ALERT SERVICE BULLETIN
REVISION NOTICE

**SUBJECT: REVISION "A" TO ALERT SERVICE BULLETIN 205-07-94:
(STARTER/GENERATOR POWER CABLE UPGRADE)**

NO. 205-07-94

SUBJECT: STARTER/GENERATOR POWER CABLE, UPGRADE.

Figure 1
Structural Modification

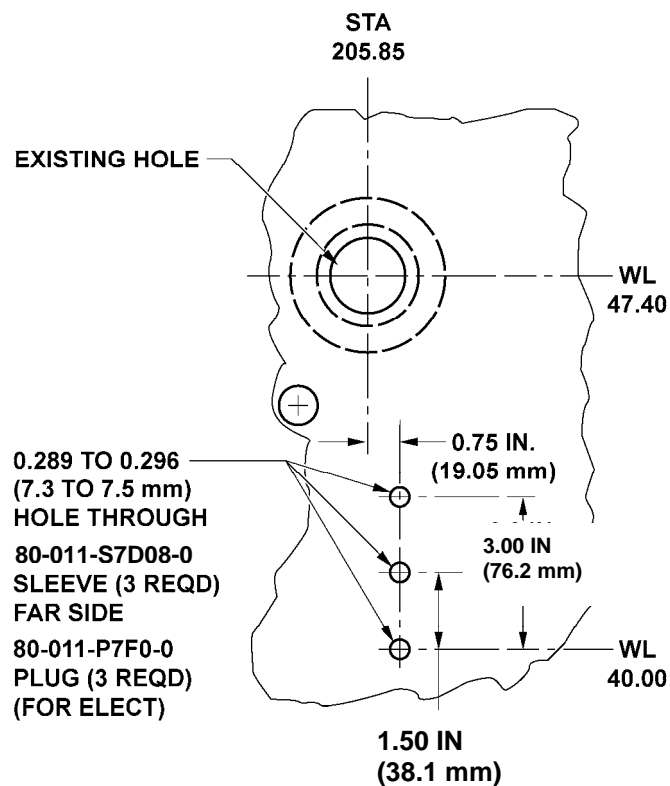
- 4) Remove wires as per Table 1. Retain hardware for re-installation.
 - 5) Install plugs and sleeves as follow:
 - a) Locate qty 3 holes in accordance with Figure 1.

- b) Drill qty 3 holes 0.296 to 0.289 inch through panel assembly as shown on figure 1.
 - c) Install qty 3 sleeves P/N 80-011-S7D08-0 far side and plug P/N 80-011-P7F0-0 using adhesive C-317 as detailed in Structural Repair Manual (SRM).
